Access Compliance Report

Public Rights-of-Way

Intersection ID: 17580	Main Street: N_SHARON_AMITY_RD	Cross Street: WALKER_RD	Location: NE
ADA ID: 16EC6F7DAA34	Ramp Type: PerpDiag	Initial Pass/Fail: Fail	Overall Compliance: No
		Severity Score: 25

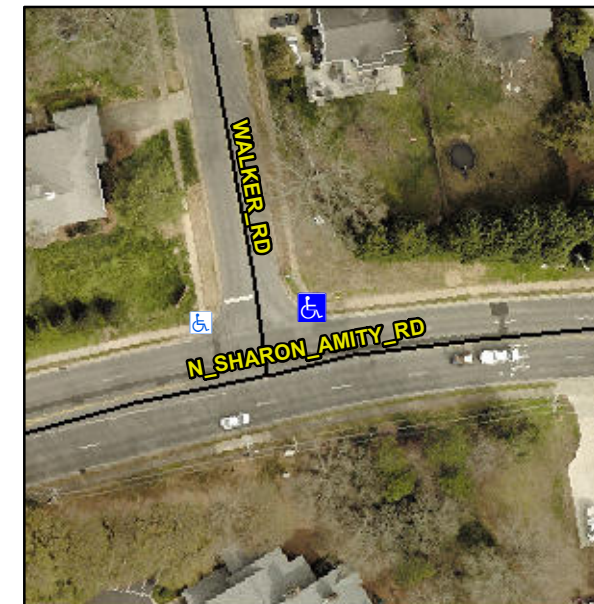
Not Found, R304.2.2, R304.5.3

Compliance	Description	Data	Compliance	Description	Data
N/A	Ramp Length (in)	54.0	No	Ramp Slope (%)	9.3
Yes	Ramp Width (in)	48.0	No	Ramp XSlope (%)	5.6
N/A	Flare Type LT	N/A	N/A	Flare Type RT	N/A
N/A	Flare Slope LT (%)	N/A	N/A	Flare Slope RT (%)	N/A
N/A	Flare Traversable LT?	N/A	N/A	Flare Traversable RT?	N/A
N/A	Landing Length (in)	N/A	N/A	DWS Provided?	N/A
N/A	Landing Width (in)	N/A	N/A	DWS Contrast?	N/A
N/A	Landing Slope (%)	N/A	N/A	DWS Length (in)	N/A
N/A	Landing X Slope (%)	N/A	N/A	DWS Full Width?	N/A
N/A	Landing Curb? (Y/N)	N/A	N/A	DWS Offset (in)	N/A
N/A	Shared Landing?	N/A			
N/A	Gutter Ponding?	N/A	N/A	Gutter Slope (%)	N/A
N/A	Gutter Lip Ht (in)	N/A	N/A	Gutter X Slope (%)	N/A
N/A	Painted X Walk1?	No	N/A	Painted X Walk2?	No
	X Walk 1 Direction	To W		X Walk 2 Direction	To S
N/A	X Walk 1 Width (in)	N/A	N/A	X Walk 2 Width (in)	N/A
	X Walk 1 Slope (%)	1.1		X Walk 2 Slope (%)	0.3
	X Walk 1 X Slope (%)	0.1		X Walk 2 X Slope (%)	0.7

Remove & Replace Curb Ramp With Two New Directional Ramps or Equivalent.
